Rezoning Transportation Analysis

Petition Number: 2016-131

From: **Kelsie Anderson, PE**

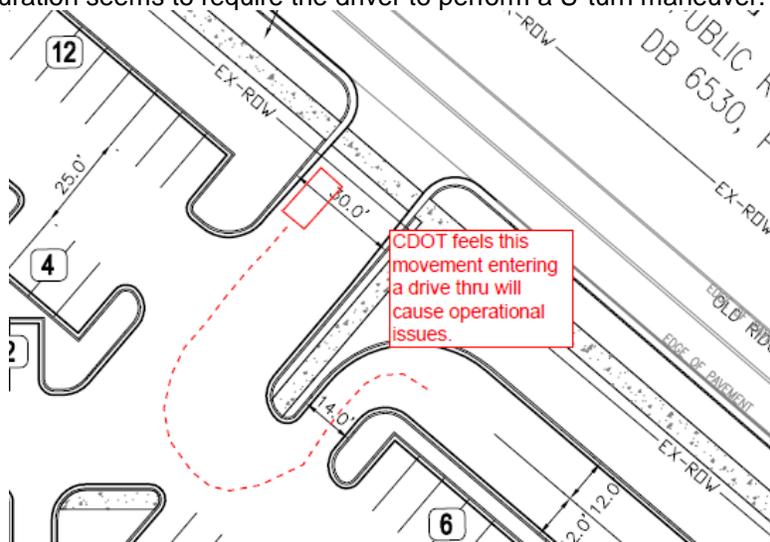
1. The petitioner should confirm the land use and intensity shown on the site plan. Approximation of the proposed building footprint is less than 5,000 sf but the site plan shows entitlements for 15,000 square feet. Based on the trips generated by the proposed land use, CDOT requires a Traffic Impact Analysis for this rezoning.

- The petitioner should submit a Transportation Technical Memorandum (TTM) to describe the anticipated internal vehicle stacking patterns - to confirm that there is no spill out on to the public streets – and to describe the internal pedestrian path connections to the public sidewalk. The current site plan configuration seems to require the driver to perform a U-turn maneuver.

- The proposed site is located in the center of the Prosperity Hucks Activity Center. The current site plan maintains Old Ridge Road in its existing alignment and form which does not conform exactly to the area plan street alignment or the adjacent approved rezoning (2008-081). Maintaining Old Ridge Road in its current form for this petition can be considered if the petitioner revises the site plan as follows to develop the street connections as envisioned in the Prosperity Hucks Area Plan:

- Add a RI/RO on Ridge Road in a location generally conforming to the previous rezoning 2008-081.
 - Add a note and label that identifies the proposed driveway on Old Ridge Road as temporary use that will be abandoned upon request. CDOT recommends the petitioner consider the placement of this temporary driveway for interconnectivity with approved plan 2008-081.

- Add a note that the petitioner agrees to abandonment of existing Old Ridge Road through future development.
 - Add a note agreeing to forego their rights to their half of the current Old Ridge Road right of way once abandonment is requested.

- The petitioner should revise the site plan to remove the driveway on Prosperity Church Road. CDOT does not support this driveway offset that would create conflicting lefts on Prosperity Church Road at existing site access across the street.

- The petitioner should revise the site plan to include a 150' southbound left turn lane on Prosperity Church Road serving Old Ridge Road.
- The petitioner should revise the site plan to show the proposed back of curb at 55' from the opposite back of curb of Prosperity Church Road set by approved rezoning number 2015-094.

- The petitioner should revise the site plan to show the proposed back of curb at 70' from opposite back of curb on Ridge Road to match the curblines set across the intersection of Ridge Road.

- The petitioner should revise the site plan to show mill and restripe Prosperity Church Road and Ridge Road along their property front for the full width of the roadway. CDOT would like to coordinate the striping pattern prior to the next submittal after analysis of the TIS or a meeting with CDOT.
